ADDENDUM NO. 8

DATE: April 27, 2020

PROJECT: ITB 20343
BETHUNE POINT WATER RECLAMATION FACILITY
GENERATOR REPLACEMENT

5 TYPICAL CMU INFILL DETAIL
SCALE: 1 1/2" = 1'-0"

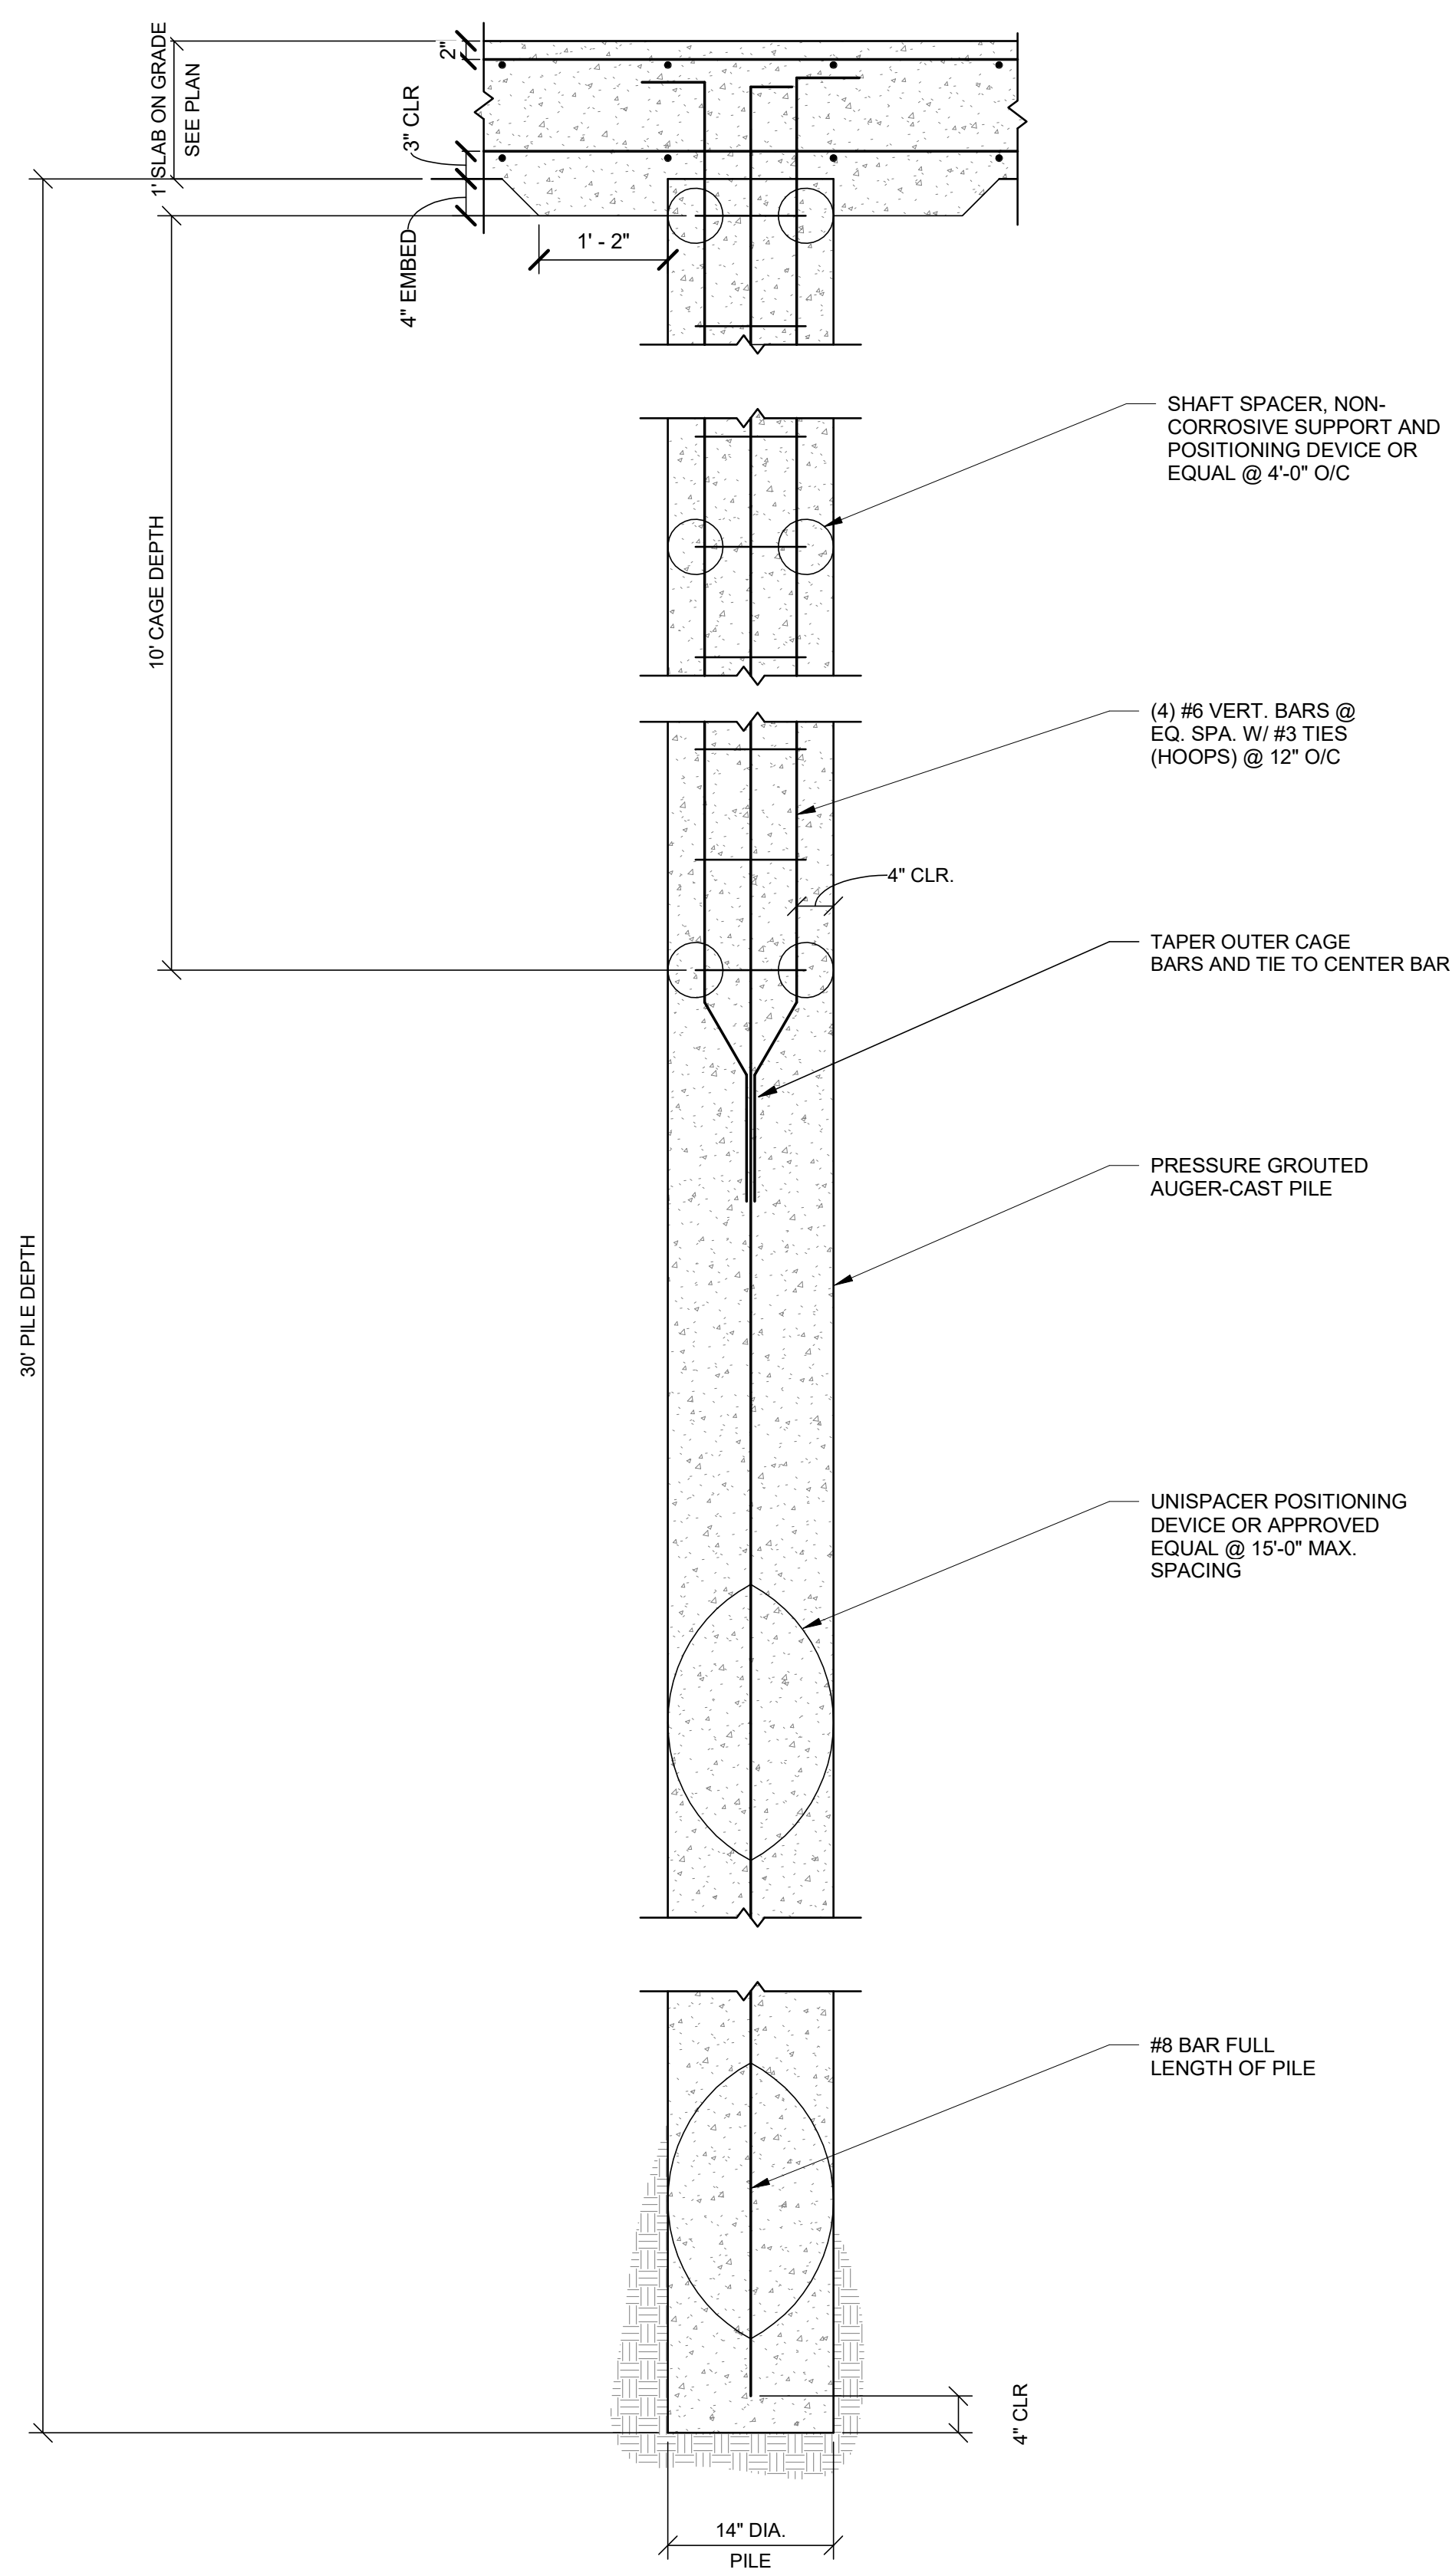
Q7: A25 in Addendum 7 indicates that the contractor shall remove all existing louvers and replace with concrete masonry to match existing building. Please provide a detail and/or specification for the masonry infill. Will any painting or exterior finish also be required? If so, please provide additional details and/or specifications.

A7: See attached Masonry Infill Detail 5/S-501. New masonry infill shall be coated with stucco finish and elastomeric coating to match existing stucco finish and color. Entire exterior of building that has had louvers removed and infilled with masonry shall be painted after masonry infill and stucco finish has been applied. Refer to sheet S-002 for stucco and coating requirements.

- NOTES:**
1. NEW CMU SURFACES SHALL BE PREPARED FOR STUCCO FINISH BY FILLING CRACKS, VOIDS AND OTHER SURFACE IMPERFECTIONS, REMOVING MORTAR DROPPINGS, CLEANING AND HIGH PRESSURE WATER BLASTING.
 2. STUCCO FINISH SHALL MATCH EXISTING STUCCO FINISH IN TEXTURE, THICKNESS, AND COLOR.
 3. ENTIRE EXTERIOR OF BUILDING SHALL BE PAINTED AFTER MASONRY INFILL AND STUCCO FINISH HAS BEEN APPLIED. REFER TO SHEET S-002 FOR STUCCO AND COATING REQUIREMENTS.
 4. CONTRACTOR SHALL VERIFY EXISTING REINFORCEMENT IN JAMB AND SILLS OF EXISTING OPENING AND THE CELLS ARE GROUT FILLED. NOTIFY ENGINEER IF JAMB AND SILLS ARE NOT GROUT FILLED.
